**New Albany Planning Commission**  
Monday, April 6, 2026 Meeting Minutes - Approved

##### **FDM-16-2026 Stack Final Development Plan Modification**

Re: FDM-16-2026 – Stack Final Development Plan Modifications

**Planning Commission Staff Report  
April 6, 2026 Meeting**

*LEFT: Approved site plan. | RIGHT: Proposed modified site plan.*

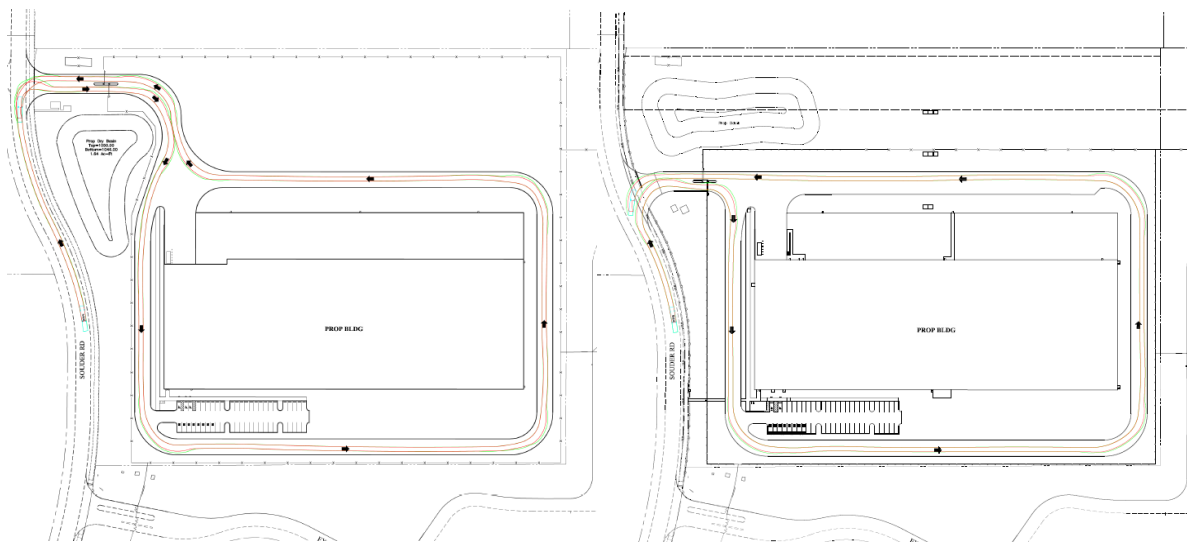
The applicant is requesting minor modifications to shift the entry drive and wet detention basin on the northwest portion of the site. This realignment is necessary due to the addition of a 100-foot-wide private utility easement along the northern boundary of the site. Additionally, landscaping has been added around the street and north of the site to meet conditions of approval from the original final development plan. Staff and the City Landscape Architect have no comments or concerns with these changes.

1. Provide more information about cross-access agreements with adjacent parcels.
2. Identify environmental features that may require ACOE or OEPA permitting.
3. Revise sheet 2 of 7, which shows the ADA parking provided is less than the ADA parking required.
4. Obtain fire department approval of the fire truck turning radius analysis.
5. On sheet 5 of 7, show the emergency overflow on the basin and remove plantings from this area.
6. Show the recorded instrument numbers for all existing easements shown on the plans.

The City Engineer has reviewed the final development plan modification and provided the following comments. Staff recommends a condition of approval that these updated comments be addressed by the applicant, subject to staff approval (condition #1).

*Proposed layout*

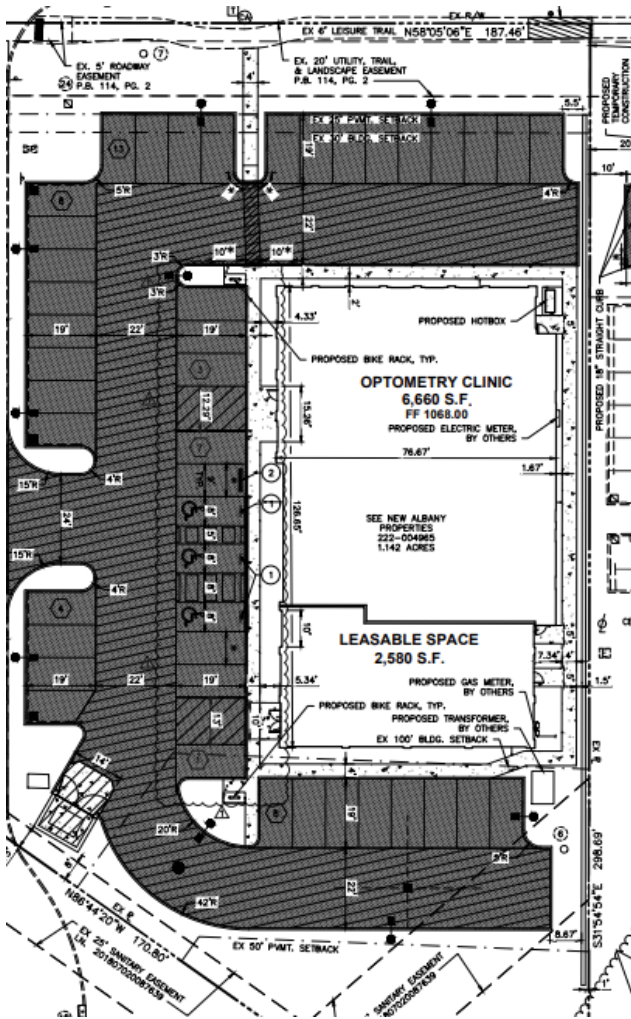
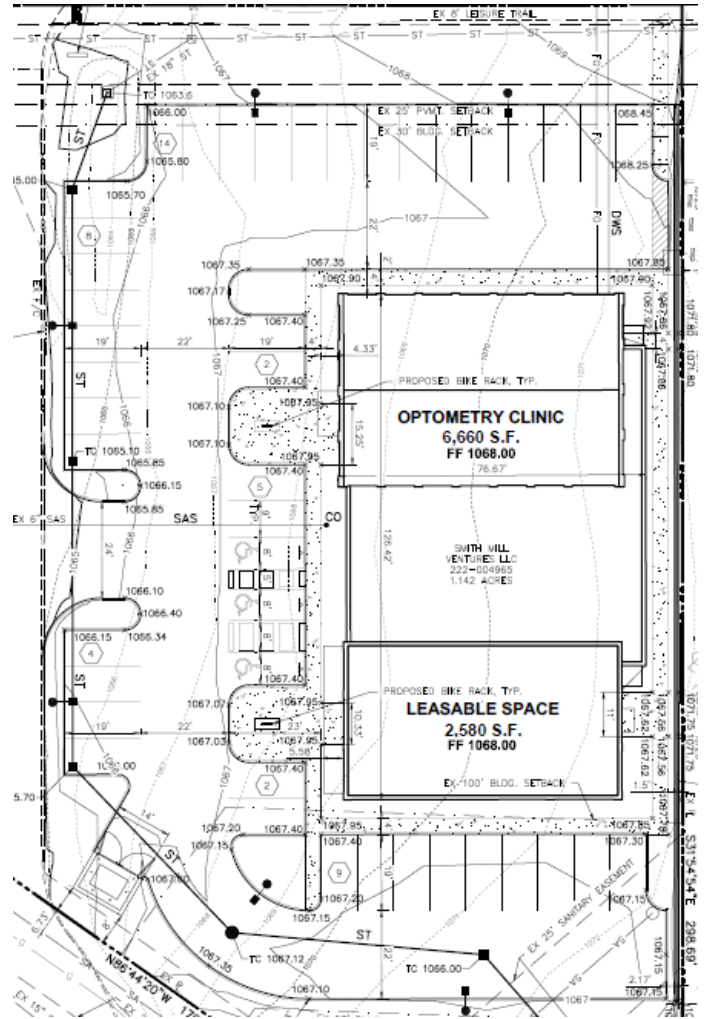
The applicant is requesting minor modification to the parking lot layout. The applicant stated that during the previous modification process, a prospective tenant requested relocation of a building entrance. Although that tenant did not ultimately occupy the space, the entrance relocation remained part of the approved plan. At that time, the pedestrian walkways were not updated to reflect the revised entrance location.

The proposed revision realigns the walkway to connect directly to the relocated entrance and removes segments of concrete walkway that would be susceptible to damage from routine snow removal and service vehicle activity (e.g., trash and delivery trucks). The updated layout enhances the pedestrian connection while maintaining the overall design intent and site aesthetics. The plan also includes relocation of the bike racks and results in the addition of two parking spaces

Staff does not have any concerns with the request.
